DEPARTMENT OF INFORMATION TECHNOLOGY

AMENDMENT #2 CATS II TASK ORDER REQUEST FOR PROPOSALS VALLEY LEE COMMUNICATIONS TOWER CONSTRUCTION PROJECT NUMBER # F50B3400031 December 6, 2012

LUGM File# 09–135–001 Sheet 4 of 6 Profile and Details Valley Lee Communication Tower

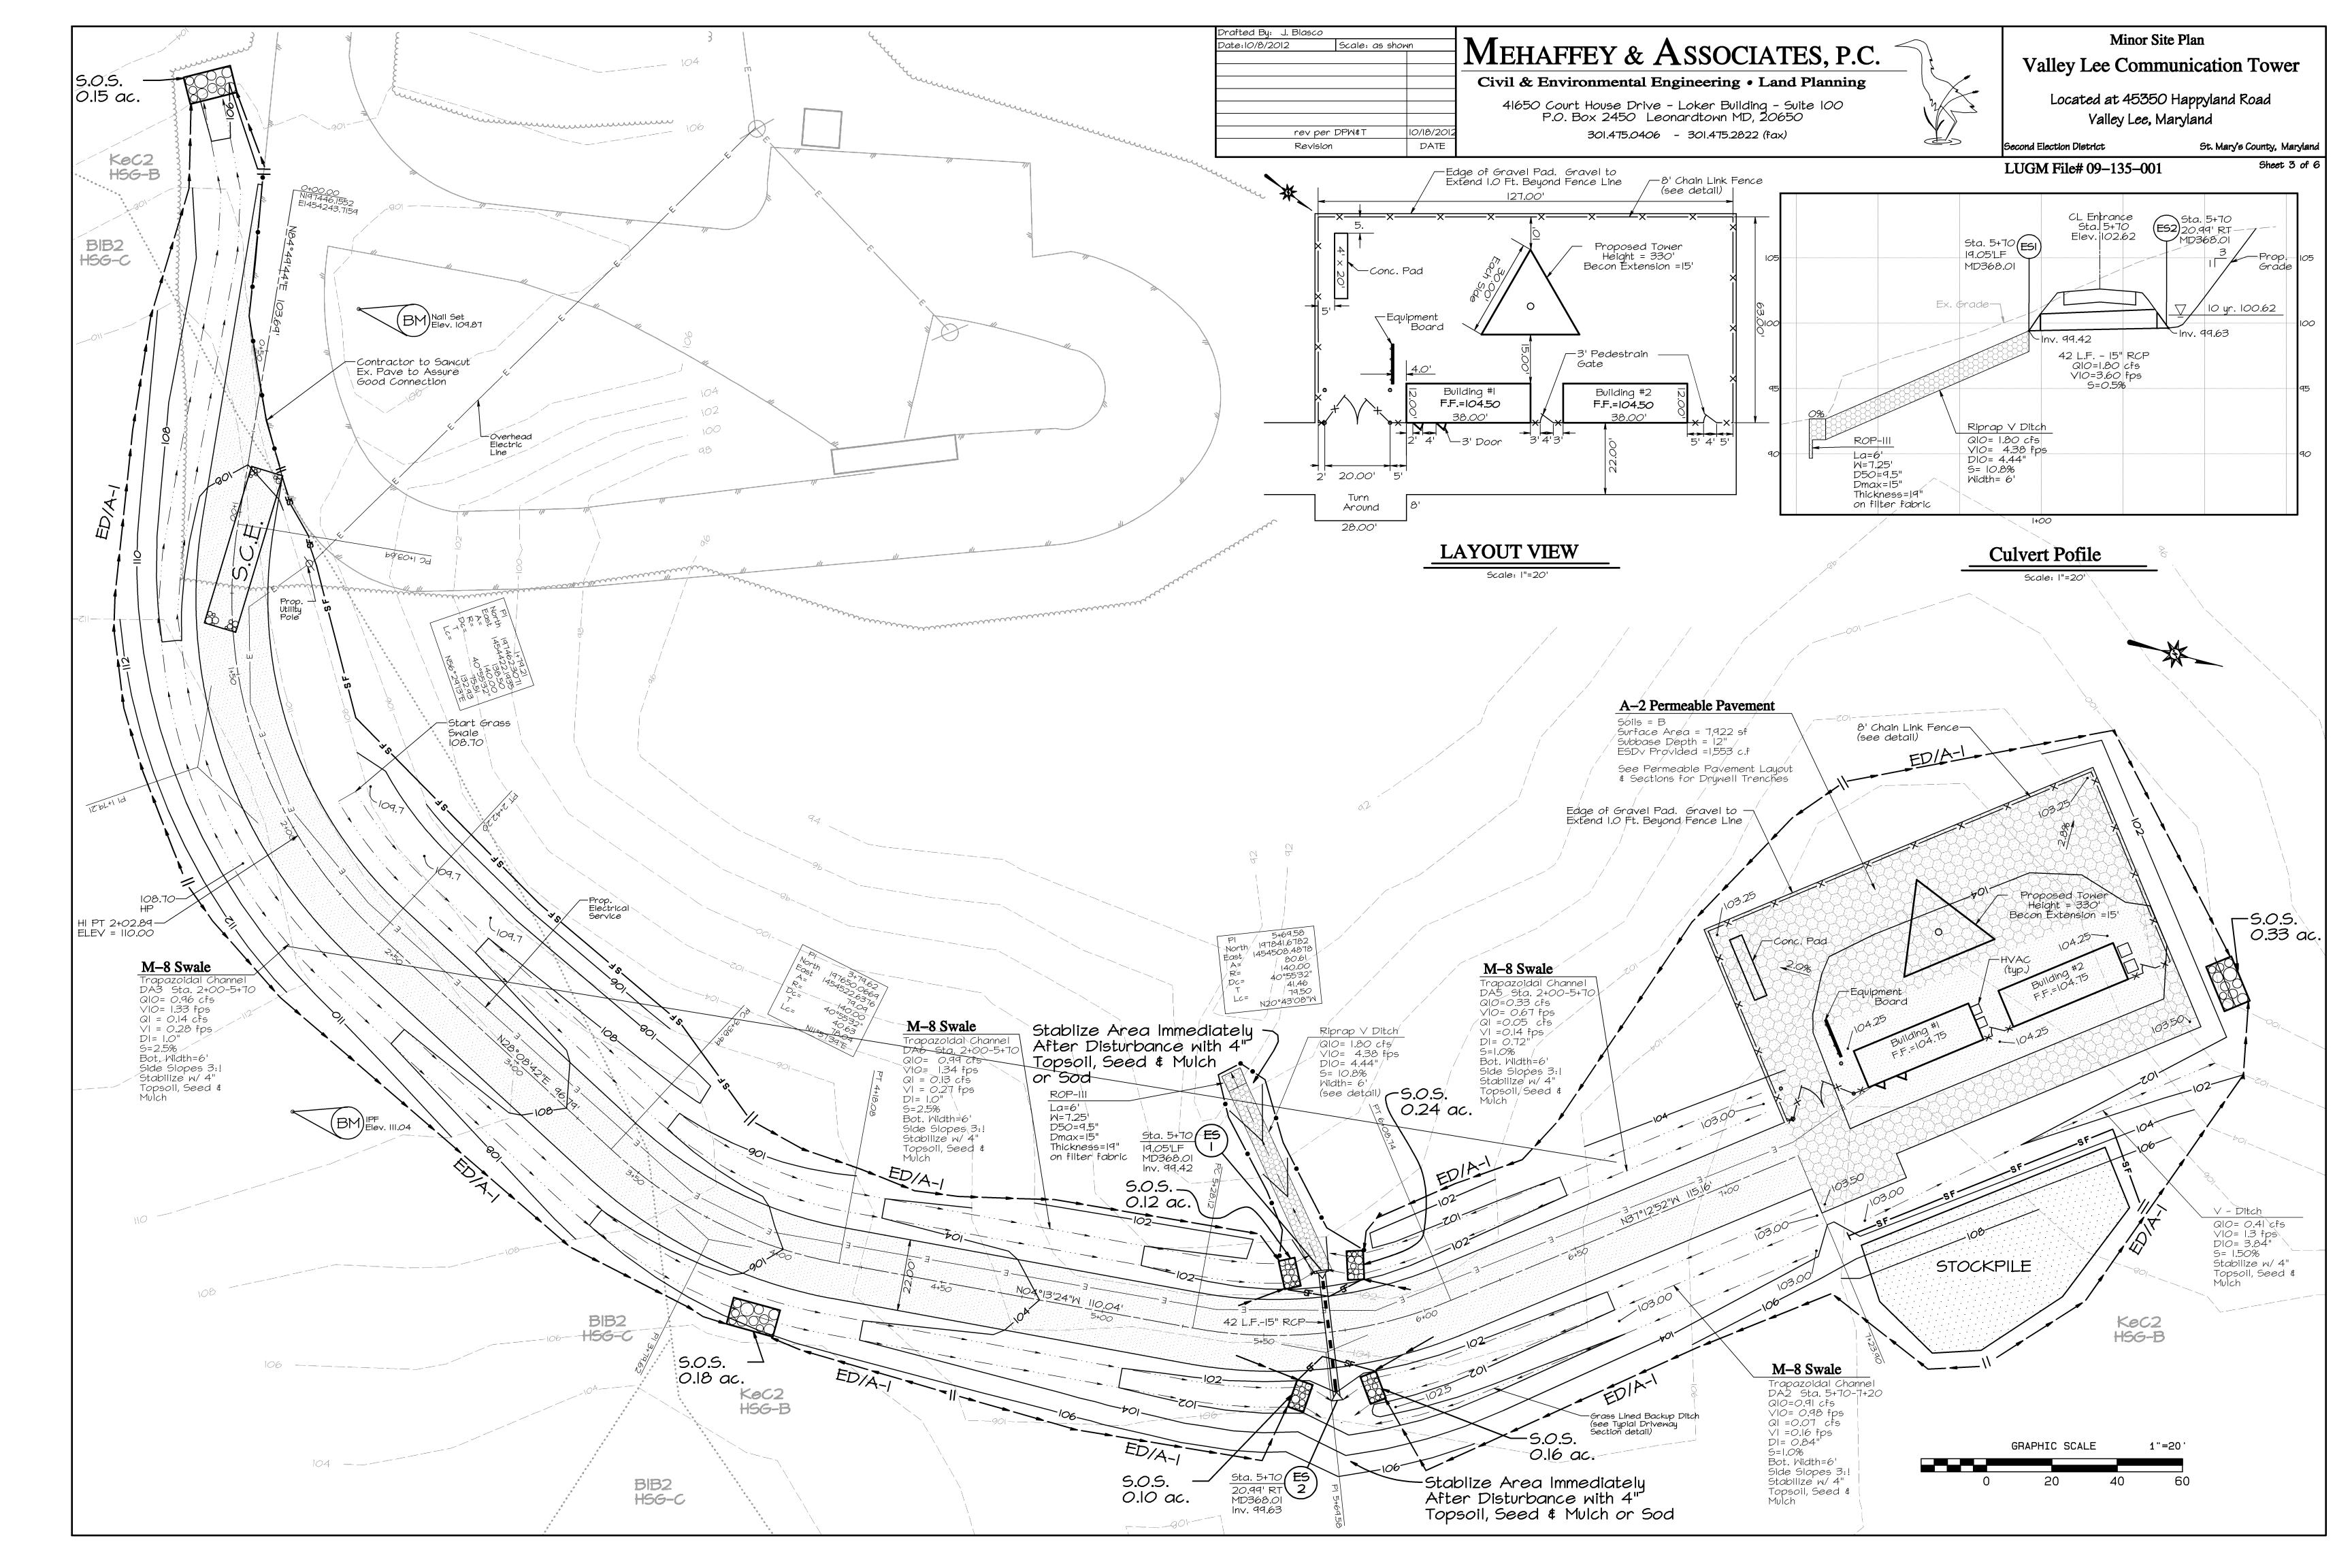
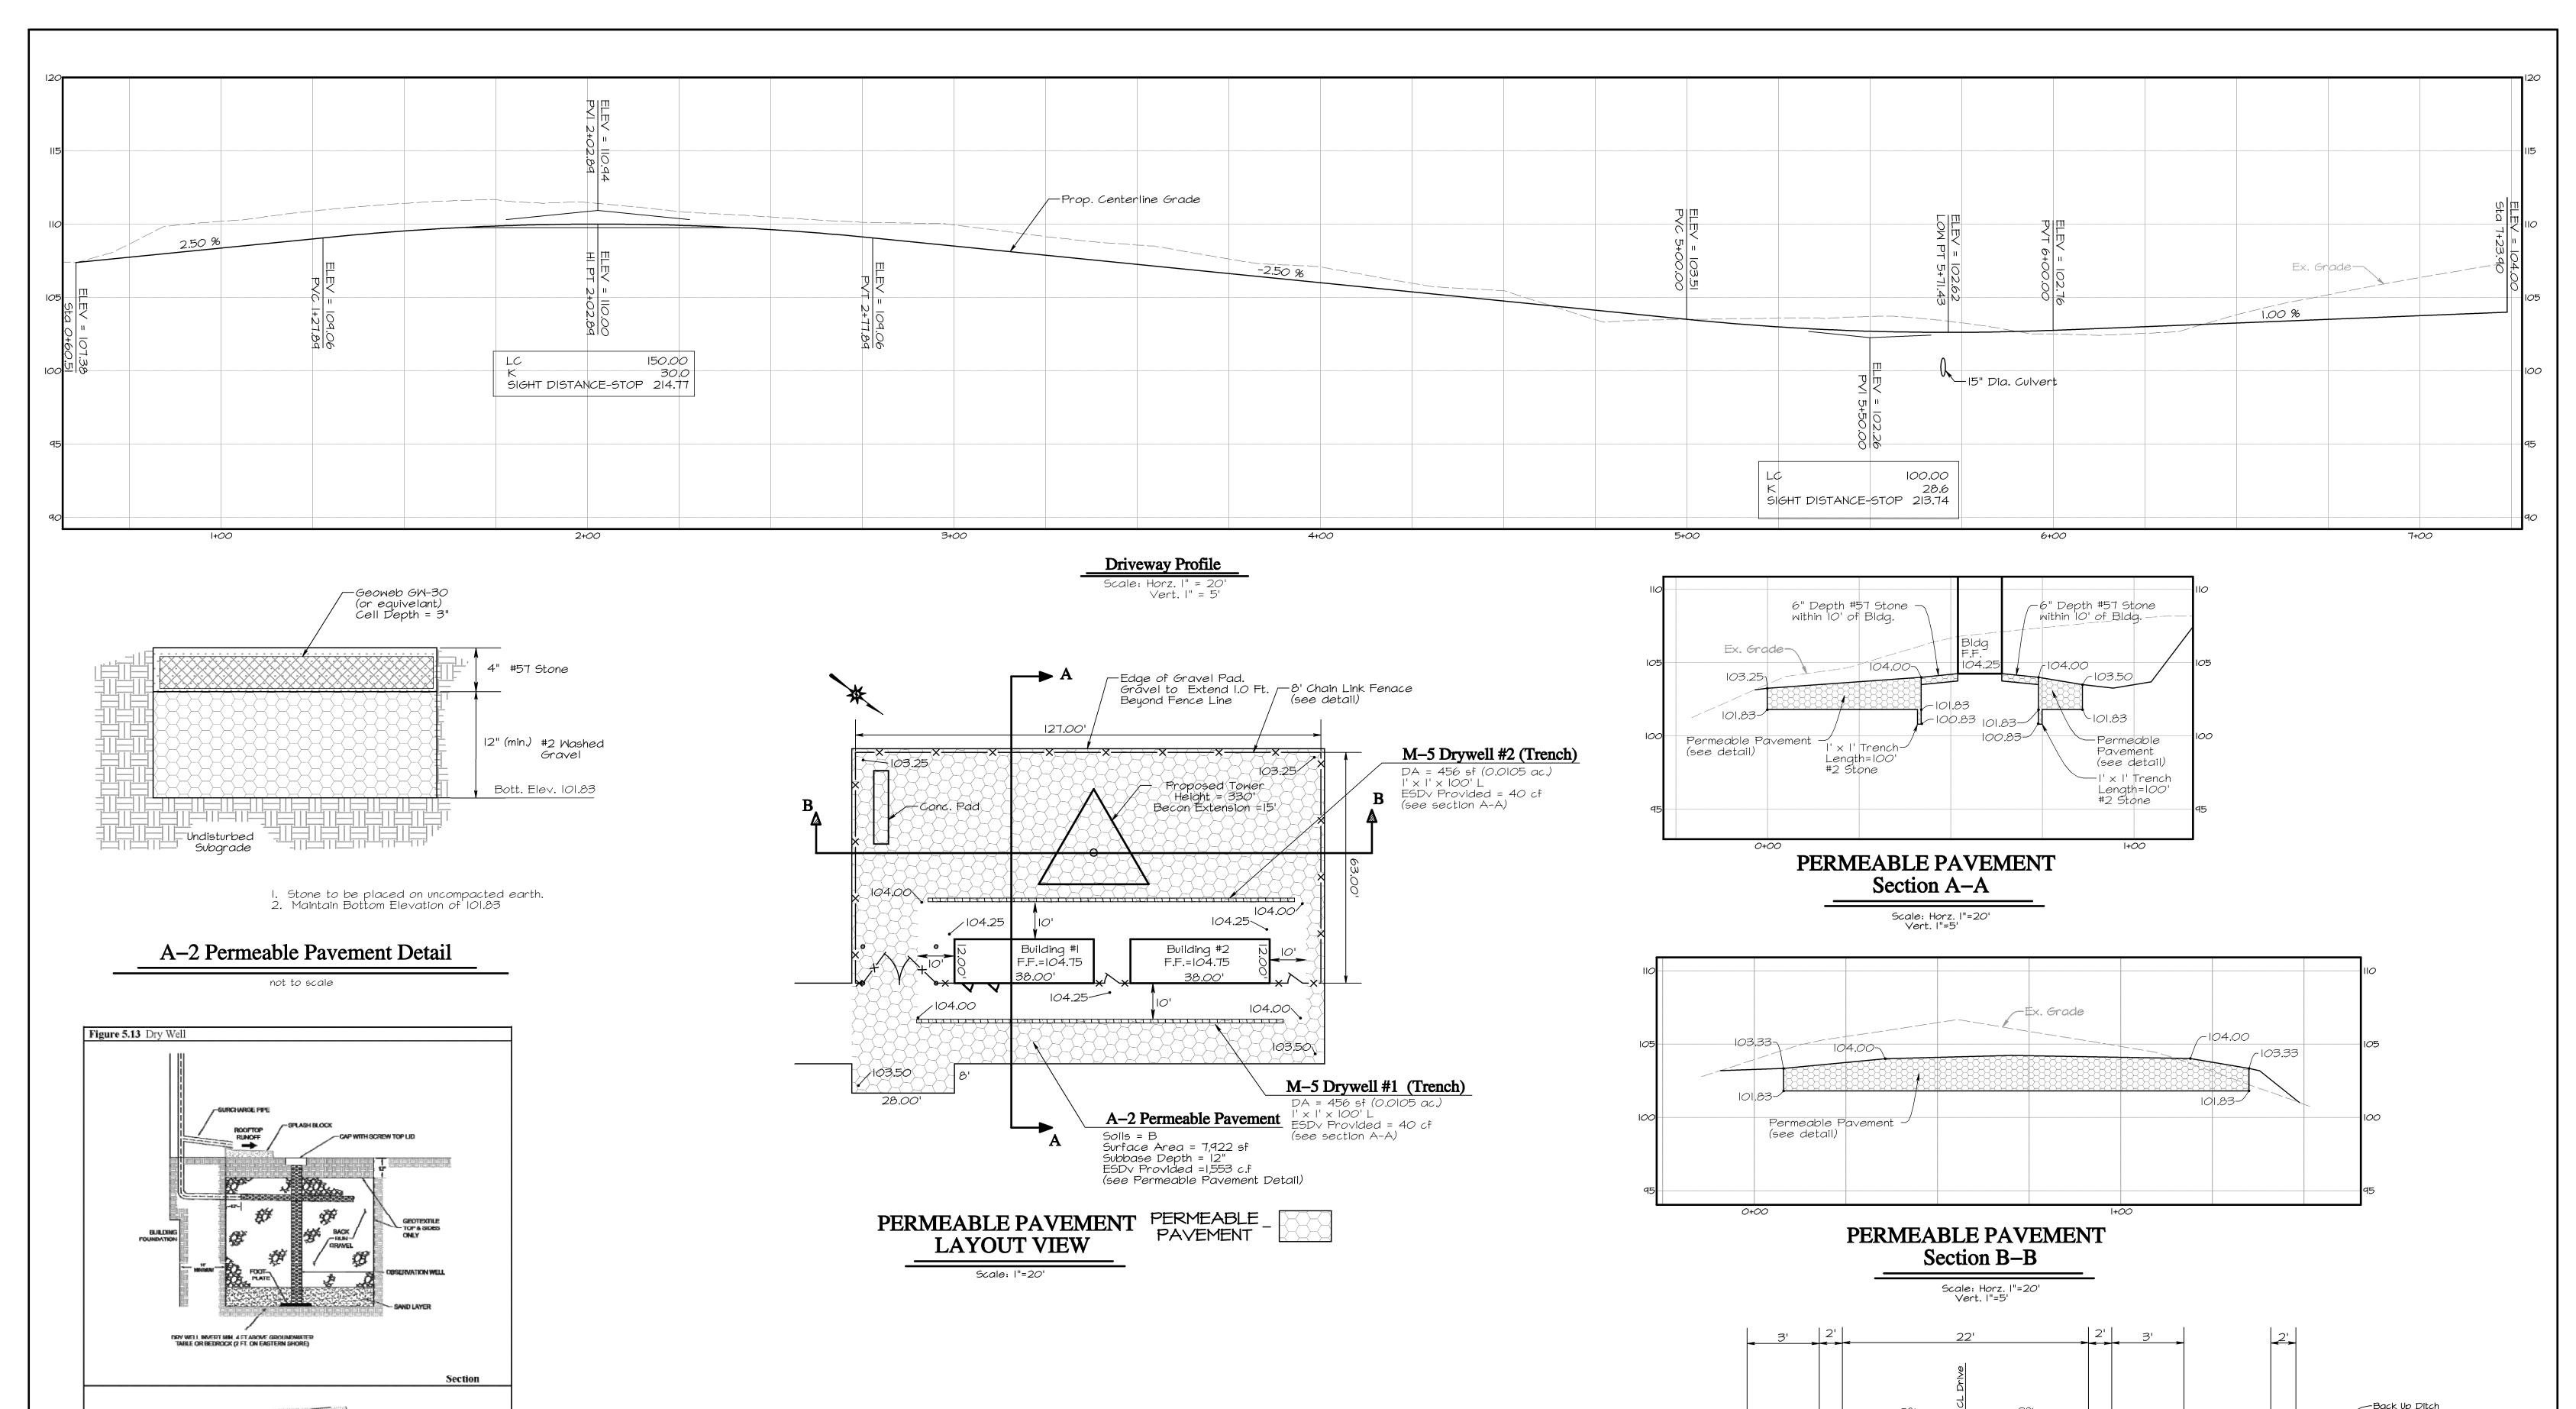
2. Enclosed are two page revisions to Attachment # 22 Construction Drawings reflecting changes to the surface material within the compound.

Drafted By: J. Blasco 0ate:10/8/2012 Revision Permeable Pavement
